# Groundwater Transfer Review Summary Form

Transfer/PA # T- 14665 (RA)

Application: T-14665

Applicant Name: Fedosiy Ivanov

**Well Interference Analysis (Theis, 1935)**

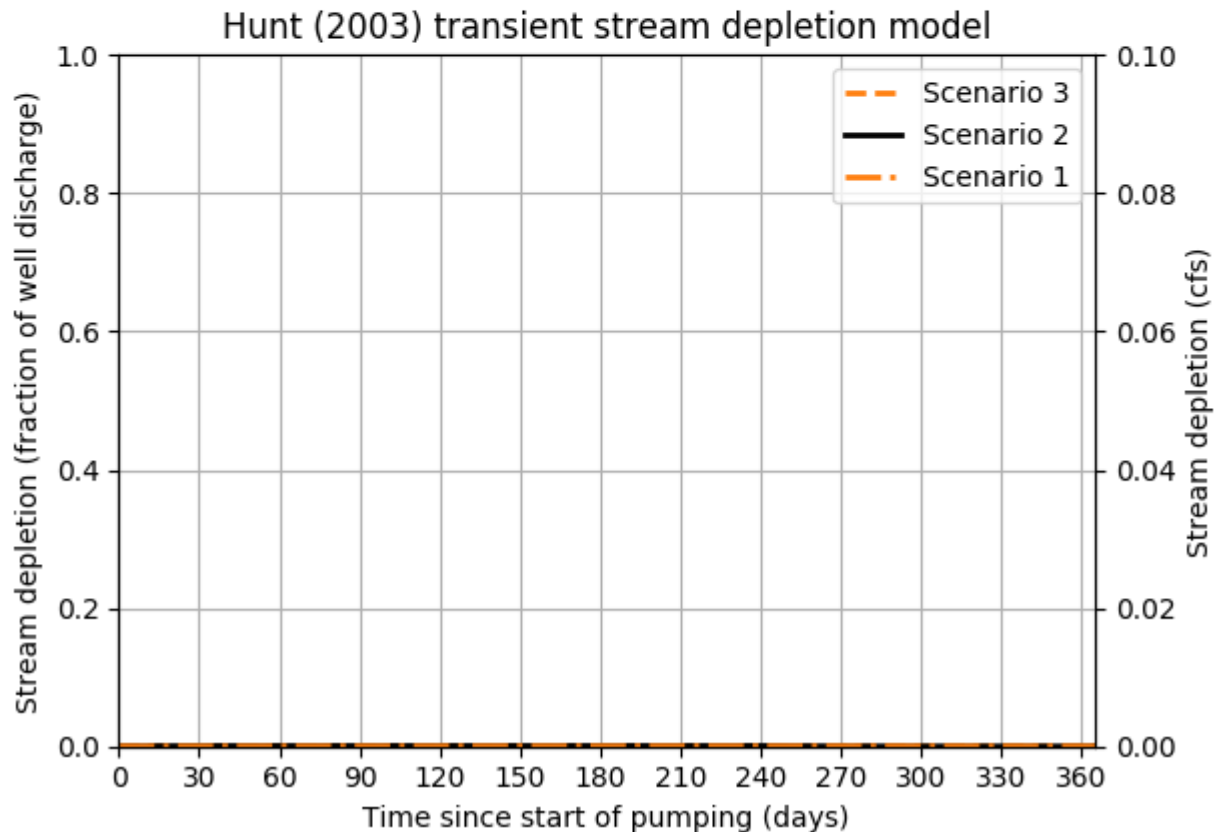
☒ Yes   ☐ No   Comments: The proposed To-POA (MARI 68707) would be ~530 ft south of neighboring well MARI 71663, authorized POA on Permit G-18660, while the From-POA (MARI 1707) is ~10,000 ft south of MARI 71663. The closer proximity of the To-POA to MARI 71663 would increase interference with MARI 71663.

☐ Yes   ☒ No   If yes, explain: Potential interference with MARI 71663 due to the proposed change was analyzed using the Theis (1935) solution for drawdown in a confined aquifer (see attached Well Interference Analysis). Results of the analysis indicate that the proposed change is unlikely to injure MARI 71663 or similar neighboring groundwater rights.

**Surface Water Interference Analysis (Hunt, 2003) (continued)**

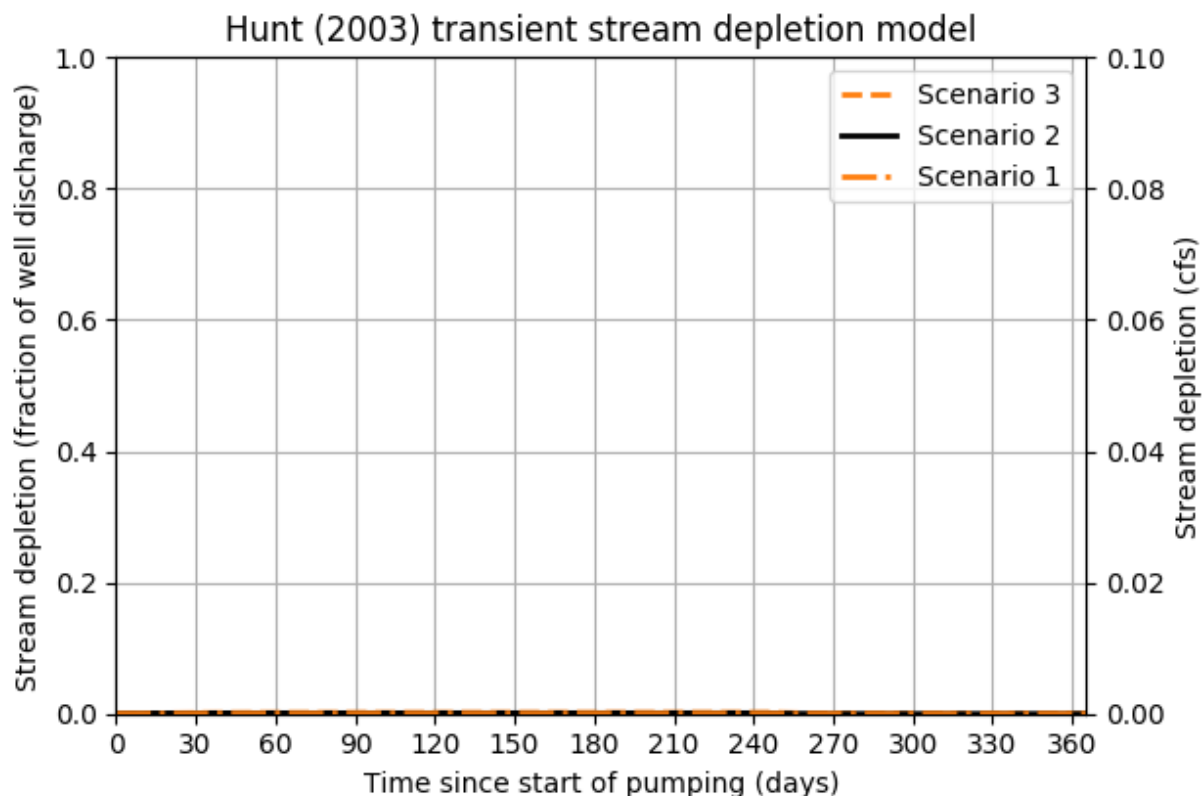
☒ Yes   ☐ No   Comments: The proposed To-POA is ~1,870 ft northwest of Mill Creek, whereas the From-POA is ~5,060 ft east of Mill Creek. The From-POA is also approximately equidistant between Mill Creek and the Pudding River, whereas the proposed To-POA is on the opposite side of Mill Creek as the From-POA. Due to its location, the proposed To-POA would be anticipated to deplete Mill Creek more than the authorized From-POA; thus, the proposed change would likely result in an increase in interference with Mill Creek.

Provide context for minimal/significant impact: The potential interference with Mill Creek was analyzed using the Hunt (2003) stream depletion model (see attached Surface Water Interference Analysis). Results of the analysis indicate that any increase in seasonal interference with Mill Creek due to the proposed change would likely be very small (<0.2% of the rate of pumping). Seasonal peak depletion due to pumping the To-POA would increase over time, eventually reestablishing a pseudo-equilibrium similar to the conditions before the transfer, with most of the depletive effect impacting larger, more incised rivers (the Willamette and Molalla Rivers) at the aquifer boundaries (Herrera et al., 2014).
